AMENDMENT OF SOLICITATION / MODIFICATION OF CONTRACT			1. Contract Number	Page of Pages 1 1
2. Amendment/Modification Number DCKT-2011-B-0037-0002	3. Effective Date See 16C Below	4. Requisition/Purchase Request No.	5. Solicitation Caption Storm Water Mgmt System

14. Description of Amendment/Modification (Organized by UCF Section headings, including solicitation/contract subject matter where feasible.) Solicitation DCKT-2011-B-0037 is amended as follows: A. As mention at the site visit please send all questions to Aaron Holland via email (aaron.holland@dc.gov) by the close of business Tuesday Jan 18, 2011. B. ADD New Specification and Drawings for Two Picnic Shelters. (See Attachment No.1). C. A copy of the attendance sheet from the Pre-Bid Site Visit is provided.				
Except as provided herein, all terms and conditions of the document referenced in item (9A or 10A) remain unchanged and in full force and effect.				
15A. Name and Title of Signer (Type or print)		16A. Name of Contracting Officer James Roberts		
15B. Name of Contractor (Signature)	15C. Date Signed	16B. District of Columbia  (Signature of Contracting Officer)	16C. Date Signed 1/14/11

The Specification for the two Picn

Steel Frame Single Roof Orchard (Hexagon) Pavilion

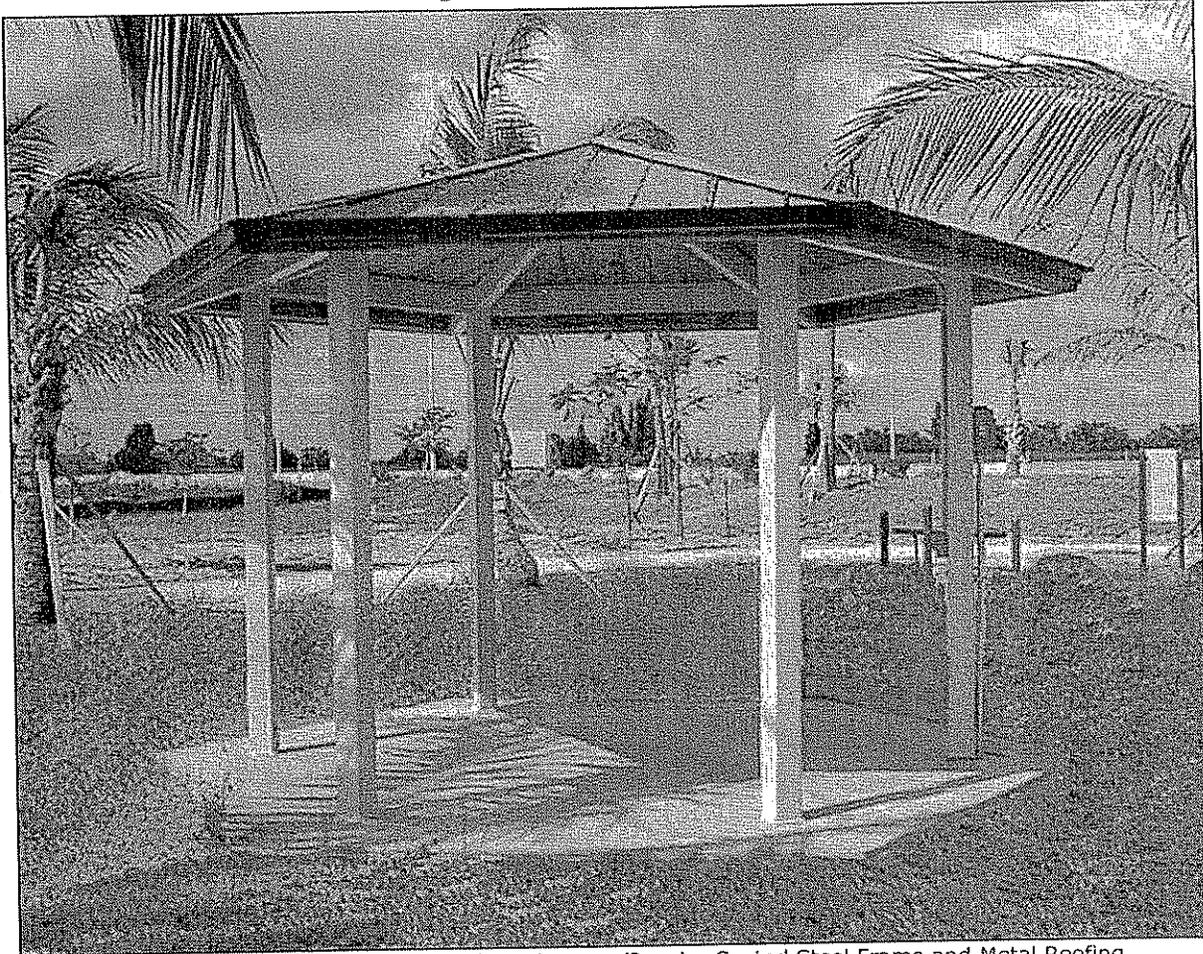
- 16' X 16' Prime Painted Steel Frame Hexagon Pavilion
- Roof : Single Metal Roof; 4:12 roof pitch
- Material: Steel Frame
- Height : 128" @ Eave
- Approximate Area : 250 Square Feet
- Columns; Buried in 3kpsi concrete, painted steel frame
- Floor: 8" concrete slab with wire mesh ,12" o.c. on 6" gravel/crushed stone on compacted soil
- Bring 3 phase, 110 Volt , double 30 amp circuits to each shelter. Use underground pvc conduits.
